## Technical Service Bulletin

**MODEL(S) AFFECTED:** S9 Walk- Behind Sweeper  
Machines shipped before June, 2013.

**SUBJECT:** Potential loss of propel due to bail not functioning properly or bail not holding adjustment after belt tensioner bracket was properly adjusted.

### Upgraded Cable Bracket

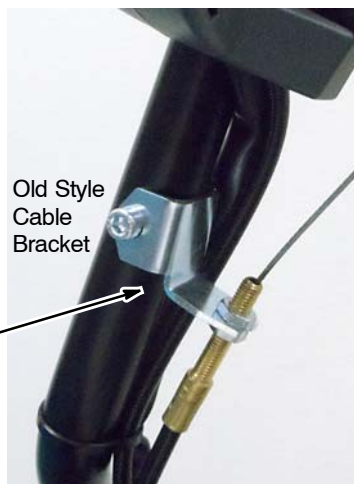
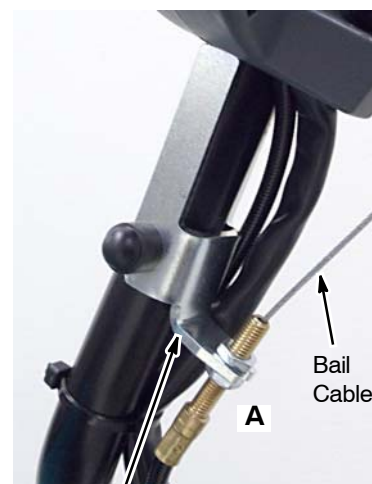
**PURPOSE:** If machine is equipped with old style cable bracket (shown below) and you experience the above condition, order the upgraded bail and cable kit p/n 9010175. The kit includes the necessary parts to resolve the propel issue as described below.

Install new cable bracket.
